TECHNICAL BULLETIN TB NO. AA-07126

SUBJECT: **Bell Helicopter Vibration Monitor (BHVM) Kit**
P/N 412-262-001 / 412-262-002

MODELS AFFECTED: Bell Helicopter Textron model 412 and 412EP helicopters with subject BHVM installed in accordance with STC SR09373RC-D.

DESCRIPTION: This Technical Bulletin is being issued to allow existing kits to be upgraded to the current configuration. The modifications aid in minimizing corrosion of the BHVM sensors and connectors.

FIGURE 2 – REORIENTATION OF TAIL ROTOR AXIAL ACCELEROMETER

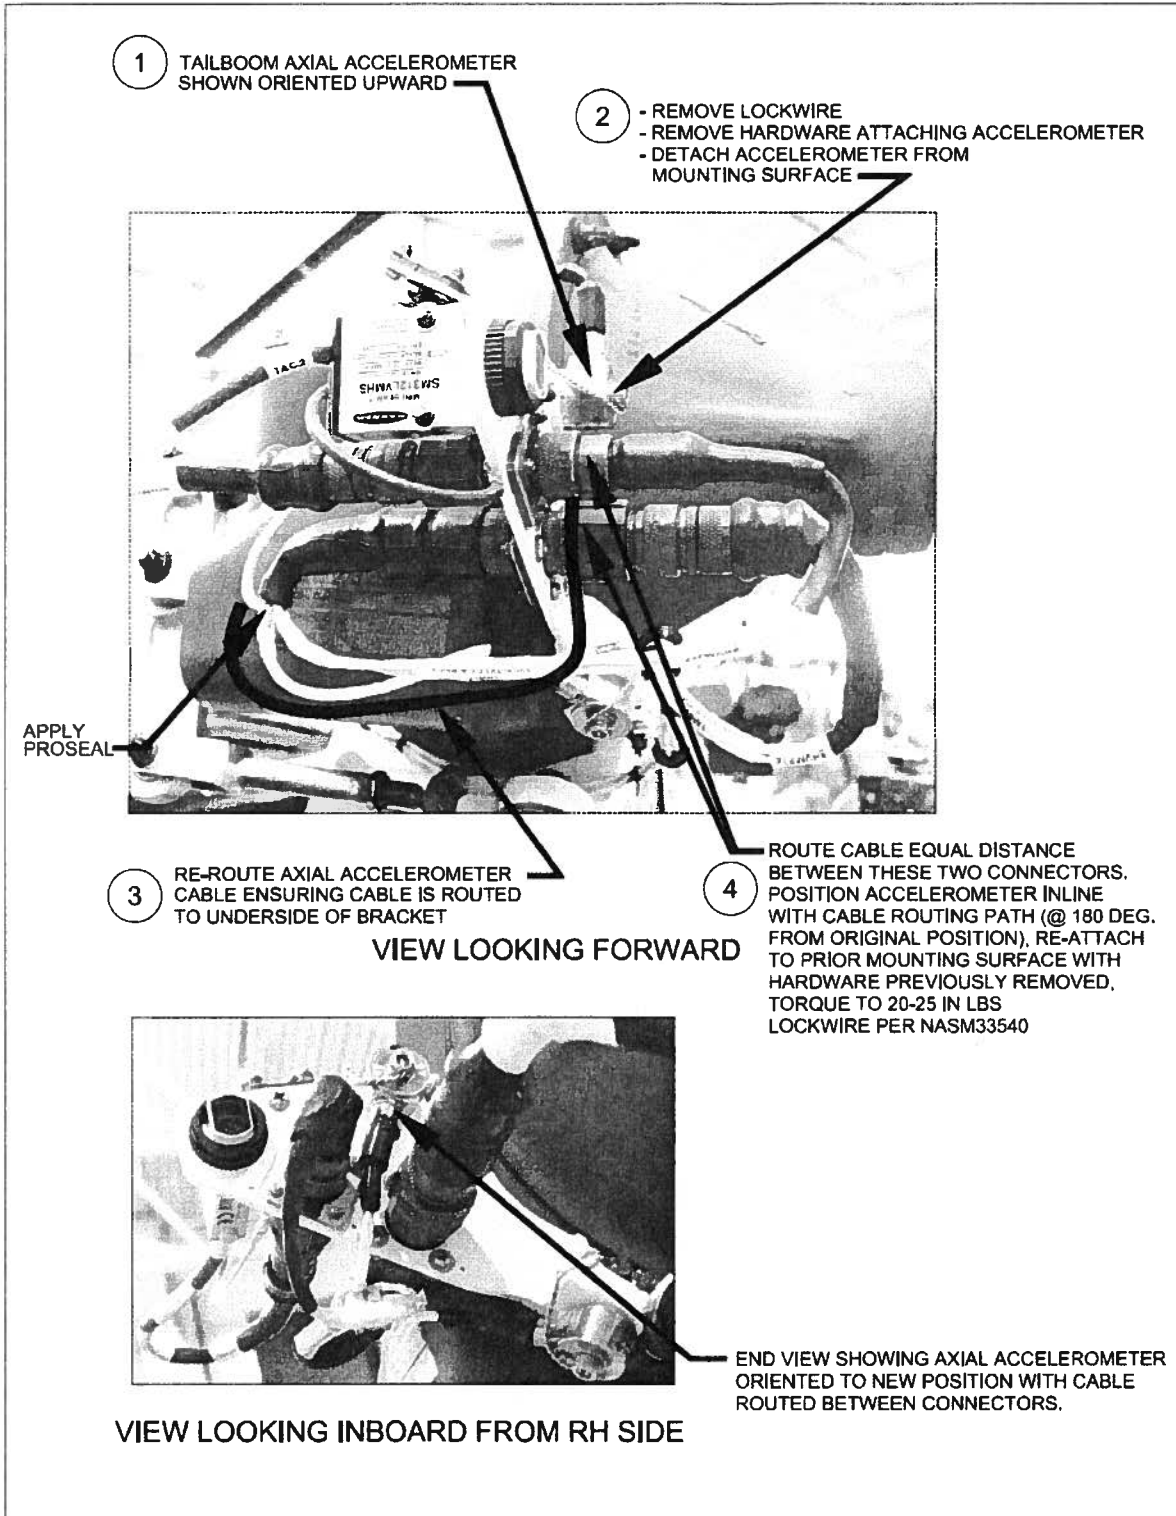
- 6.3.1 Refer to Figure 1 for location of 1209-3226-CA-01-REV4 Sensor Cable Assembly / Tail Rotor Axial referenced in Table 4.
- 6.3.2 Remove accelerometer from mounting position per ICA AA-04049 Section 5.1.21, Step 1.
- 6.3.3 Apply Proseal to accelerometer rubber boot per Dytran Service Bulletin SB002, Rev A, or later approved revision.
- 6.3.4 Reinstall accelerometer per ICA AA-04049 Section 5.2.18, Step 2, ensuring orientation of accelerometer is oriented downward as shown in Figure 2.

FIGURE 3 – TAILBOOM DISCONNECT BRACKET REPLACEMENT

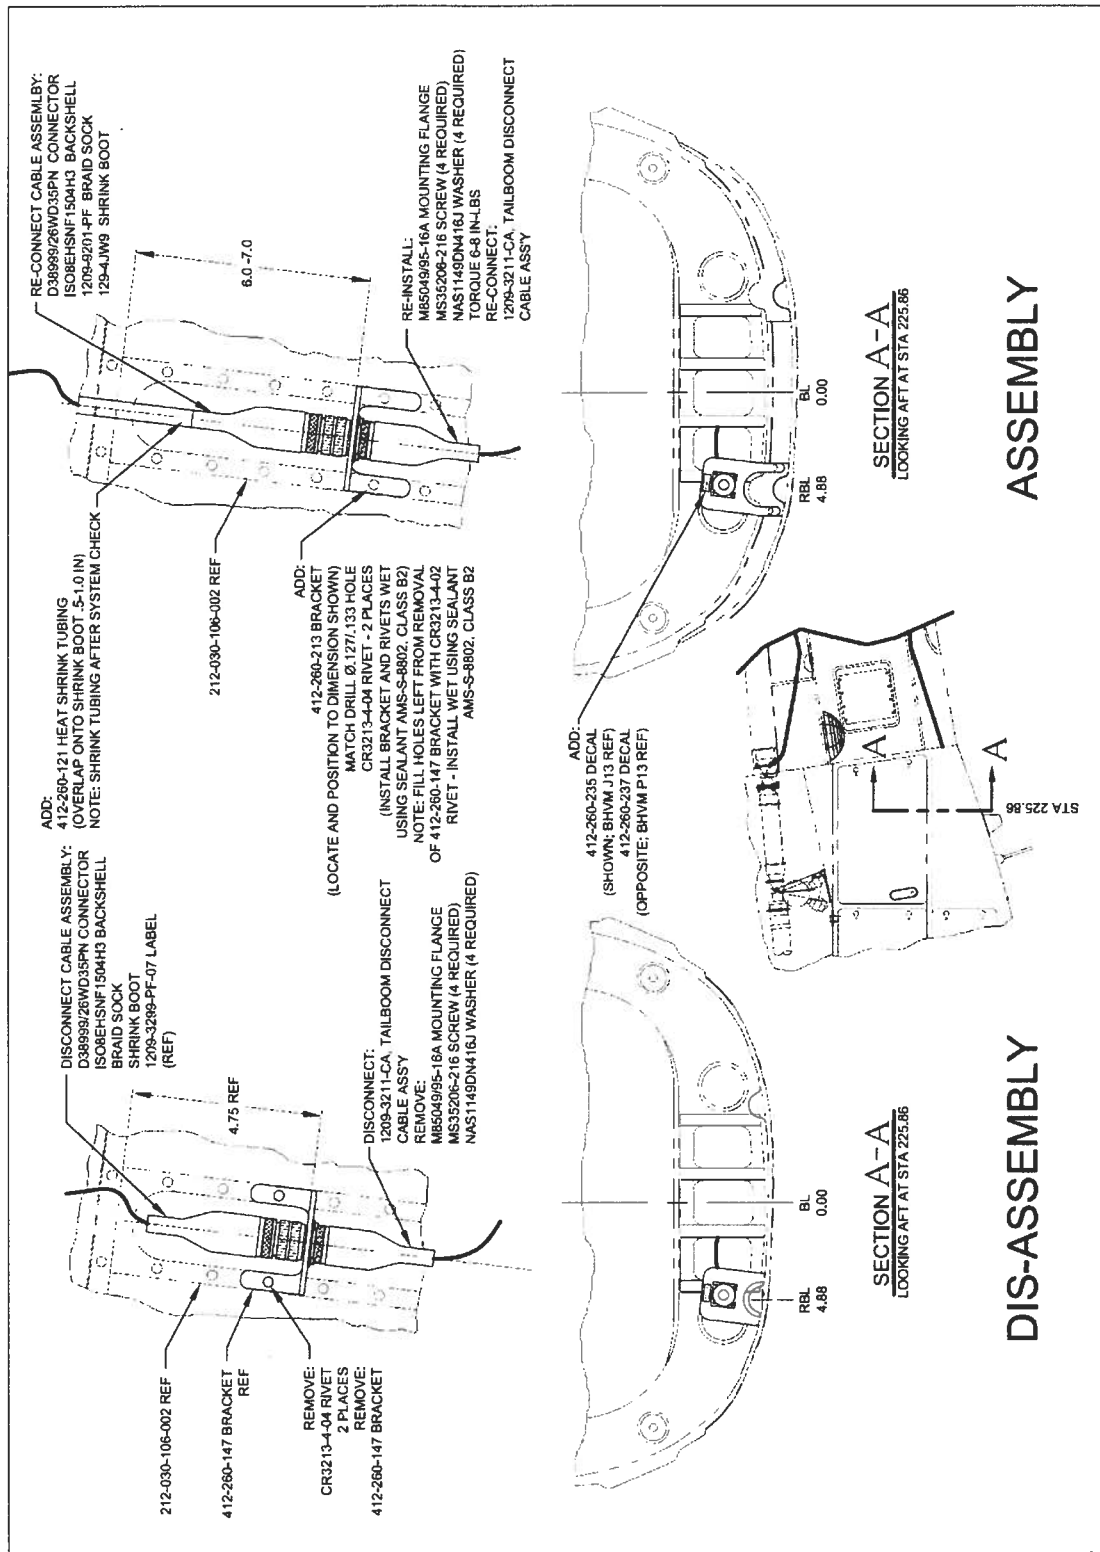
(Refer to Figure 3)

- 6.15.1 Disconnect cable labeled BHVM P13 from the aft side of the 412-260-147 Bracket
- 6.15.2 Disconnect connector J13 on 1209-3211-CA Tailboom Disconnect Cable Assembly from the forward side of 412-260-147 Bracket (see Figure 3) by removing the four MS35206-216 Screws and NAS1149DN416J Washers from the M85049/95-16A Mounting Flange that attaches the connector to the Bracket. Retain parts.

- 6.15.5 Carefully remove CR3213-4-04 Rivets retaining the 412-260-147 Bracket. Remove Bracket.
- 6.15.6 Locate 412-260-213 Bracket as shown in Figure 3. Carefully remove two rivets from 212-030-106-002 Stiffener (ref.) in aircraft in area under 412-260-213 Bracket location.

- 6.15.7 Transfer .127/.133 diameter holes from Stiffener to Bracket. Coat mating surfaces of Bracket and aircraft with Sealant AMS-S-8802 and install Bracket using CR3213-4-04 Rivets. Install rivets wet with Sealant AMS-S-8802.

- 6.15.8 Fill holes left from 412-260-147 Bracket using CR3213-4-02 Rivets. Install rivets wet with Sealant AMS-S-8802.
- 6.15.9 Brush Alodine bare aluminum per MIL-DTL-5541.

FIGURE 4 - TAILBOOM WIRING SCHEMATIC

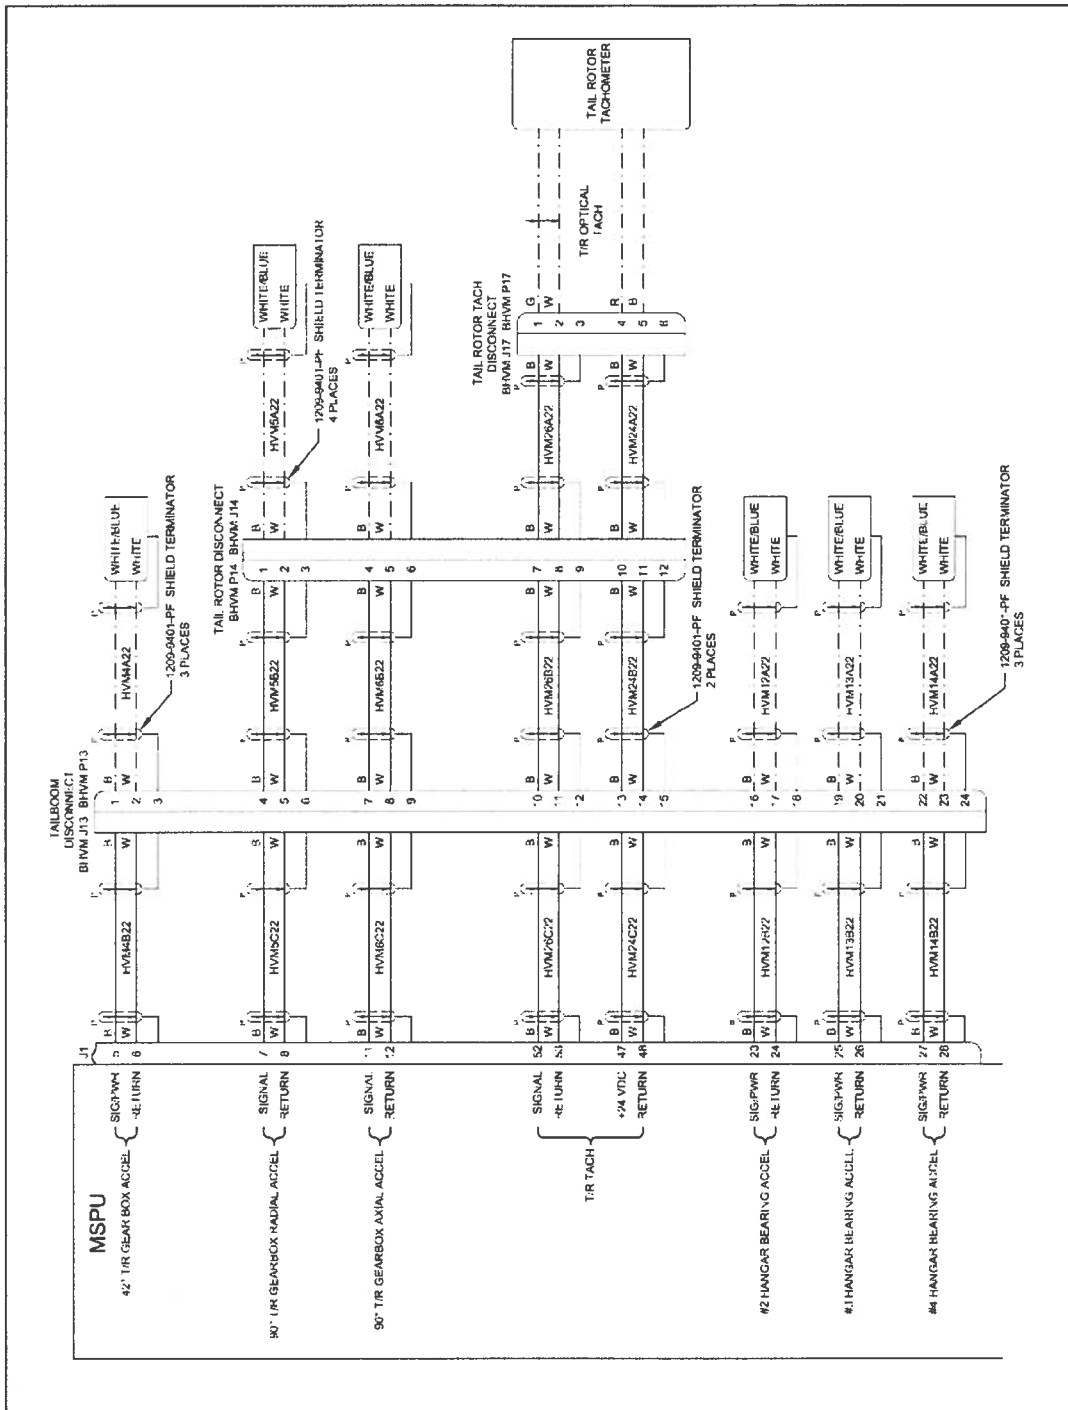
- 3. If replacement of connector pins is required, crimp connector pins on wires using Crimping Hand Tool, M22520/2-01, and Die, M22520/2-07. Install pins into connector using Insertion/Extraction Tool, M81969/14-01 – see Figure 4 for wiring terminations.
